Supplement No. 1

Service Bulletin No. 543A

This Supplement No. 1 to Service Bulletin No. 543A provides an alternate means of compliance with Service Bulletin No. 543A.

Figure A

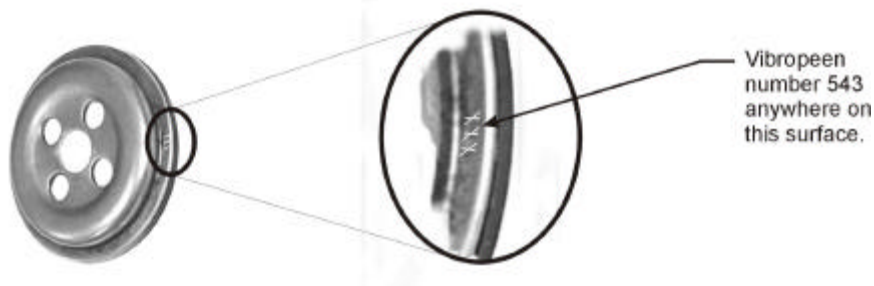
1. Replace the P/N LW-13388 gasket with a new gasket P/N 06B23072 in accordance with Textron Lycoming Service Instruction No. 1453. For identification, new gaskets P/N 06B23072 have been stamped with their part number.
2. After bonding the P/N 06B23072 gasket in place, vibropeen the number 543 anywhere along the outer surface of the plate flange as shown in Figure A.
3. Reinstall the plate and oil filter in accordance with Service Instruction No. 1453. This relieves the requirement of the replacement of the converter plate gasket at every 50 hours.

**After converter plate is marked with 543, P/N LW-13388 gasket may never be used again.**

**After kit P/N 54E23073 or kit P/N 05K23074 is installed, P/N LW-13388 gasket may never be used again. The converter plate included in each of these kits is identified with the part number 54E23073 permanently marked on the plate in the same location as shown in Figure A.**
